IS: 884 - 1985 (Reaffirmed 2005)

SPECIFICATION FOR FIRST-AID HOSE-REEL FOR FIRE FIGHTING

AMENDMENT NO. 3 DECEMBER 2008 TO IS 884 : 1985 SPECIFICATION FOR FIRST-AID

HOSE-REEL FOR FIRE FIGHTING

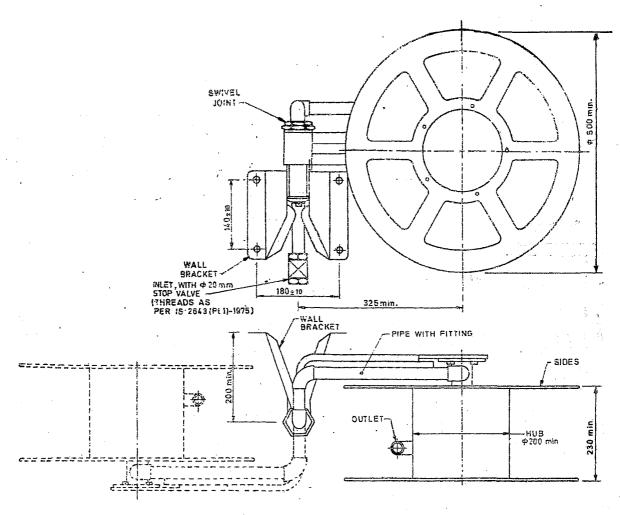
(Page 7, clause 5.3.1):

a) In the title substitute 'Impact Resistance Test (Strength Test)' for 'Impact Test'.

b) Insert the following after first sentence:

'The length of the steel bridge shall be such that it extends by at least 10 mm on either side of the two round plates when kept on them. The steel bridge shall have two numbers of suitable parallel grooves, say 10 mm wide and 5 mm deep to ensure that the bridge shall not slip and fall down during the conduct of Impact resistance test.'

c) Substitute '5.4.1' for '5.2.1' in line 6.

d) Insert the following before last sentence:

'As a result of single impact due to free fall of 25 kg mass from a height of 300 mm the reel shall not get deformed and the distance between the parallel round plates shall not change.'

(*Page 8, Fig. 3, Captions*) — Substitute 'DETAIL OF IMPACT REISTANCE TEST ON TYPE A HOSE REEL' for 'DETAIL OF IMPACT TEST'.

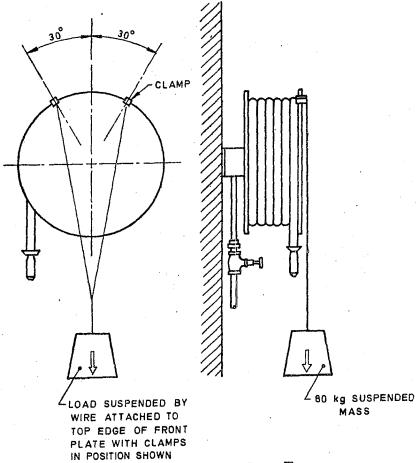
(Page 7, clause 5.3.2):

a) In the title, substitute 'Load Resistance Test' for 'Load Test'.

b) Substitute the following for the existing first sentence:

'A mass of 80 kg is suspended using steel wire ropes on the top edge of front round plate (with clamps) constituting one side of the hose reel.'

c) Substitute '5.4.1' for '5.2.1' in line 4.

(*Page* 9, *Fig.* 4, *Captions*) — Substitute 'DETAIL OF LOAD RESISTANCE TEST ON TYPE A HOSE REEL' for 'DETAIL OF LOAD TEST'.
